## Development Permit Panel

Wednesday, November 16, 2016  
3:30 p.m.

**Re:** Application by 0884100 BC Ltd. for a Development Permit at 9611, 9631 and 9651  
Blundell Road

PLAN #4

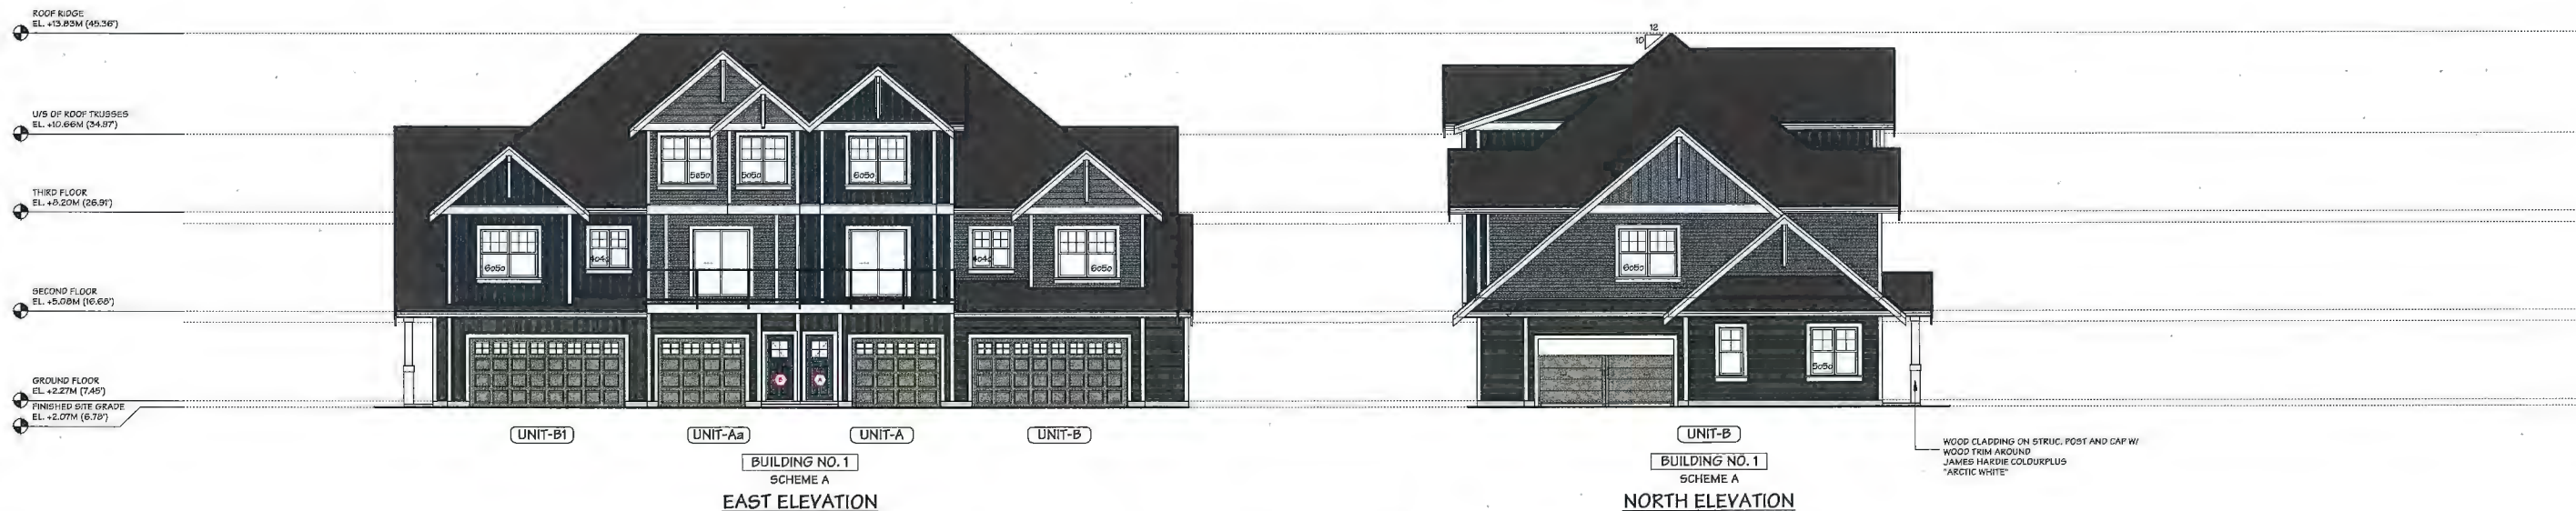
3. south elevation of Building No. 4 needs further articulation to match the character of other buildings in the proposed development; review the rooflines, materials and cladding of Building No. 4 to relate better with the other buildings;  
*Box out windows added to the south elevation to further match the character of the other buildings. Building 4 split into two buildings (duplex and single unit) to reduce the massing. The slope of the hip roof for Buildings 4 and 5 reduced to emphasize the gables. Unit Cb (Building 4) pushed 0.3m to the south for further setback from the property line.*

MAILBOX STRUCTURE  
SCALE: 1/4" = 1'-0"

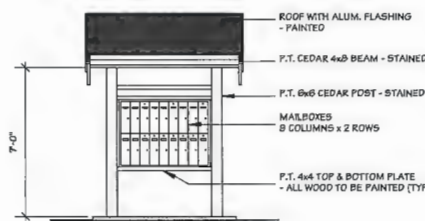
1. the proposed development fits well with its neighbourhood context;  
*We appreciate the Panel's comment.*
2. scale of the proposed mailboxes in the site and landscape plans appears small and is Not consistent with the dimensions shown in the detailed architectural drawings;  
*Scale of proposed mailboxes revised.*

12. agree with the comment regarding scale issues of mail kiosks;  
***Scale of mail kiosk revised.***
13. the children's play area appears constrained; look at the narrow "throat" between the play structure and the visitor parking stall and review the siting of the mail kiosks and bike rack; eliminate the strip of planting separating the small paved area and the internal drive aisle to provide extra paving and alleviate the pinch points in the outdoor amenity space;

PLAN #9

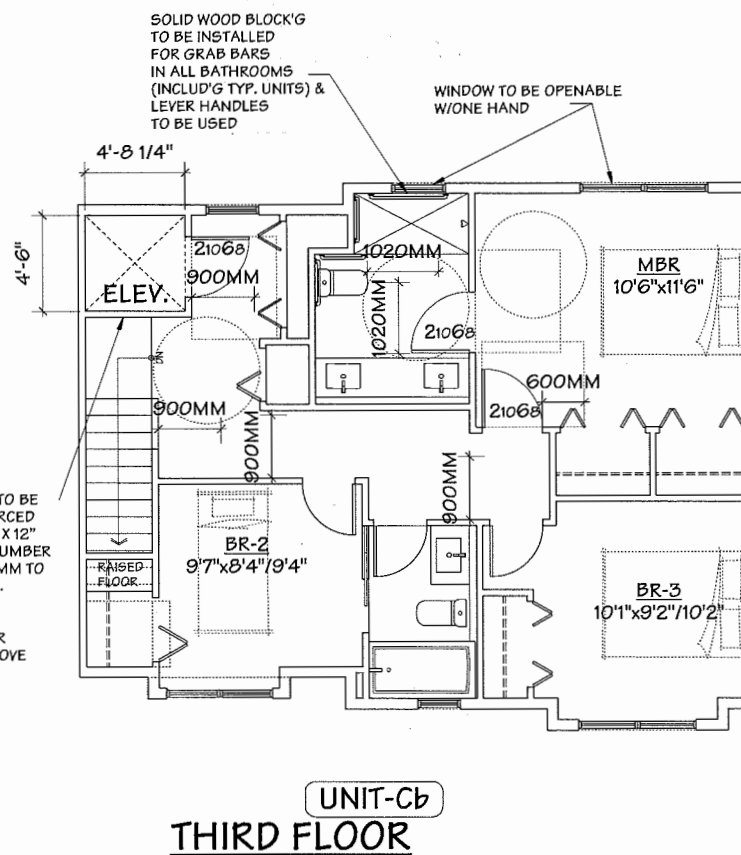
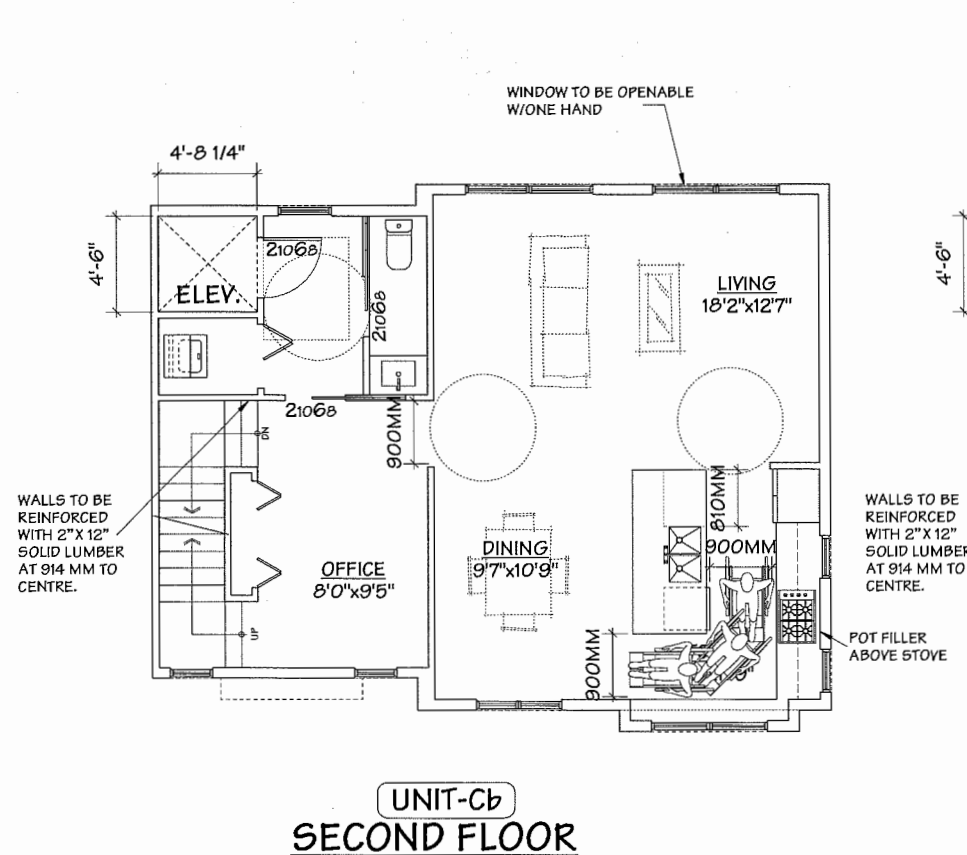
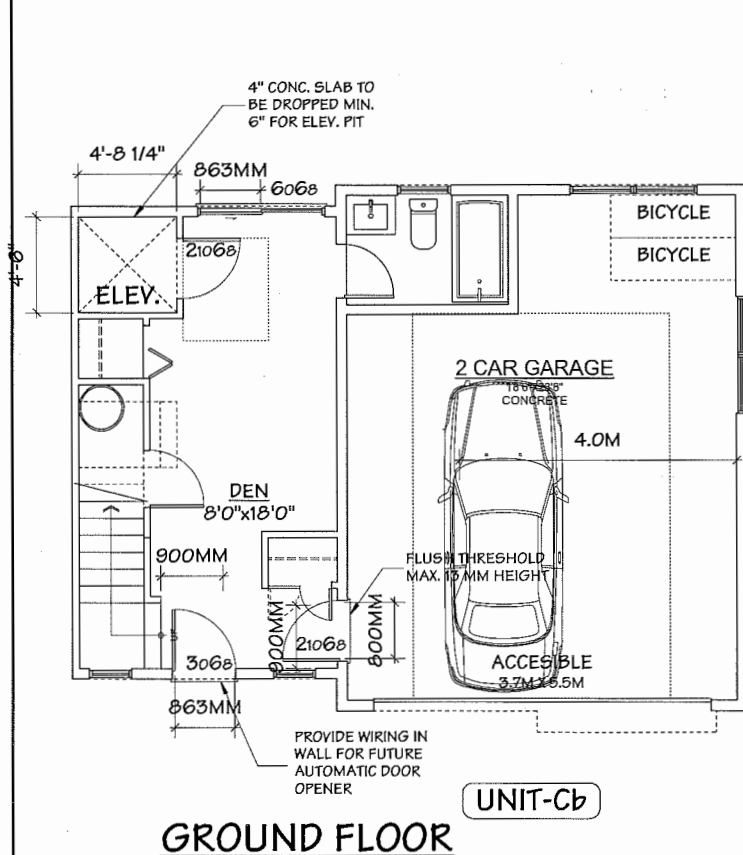
***Notation for pot filler above the stove added to the convertible unit plan, Plan #9.***
8. efficient use of a small site; density works well on the site; appreciate the use of permeable pavers; good siting for the outdoor amenity area; consider boosting the fencing at the corner of Blundell Road and Bridge Street to make the corner more attractive;
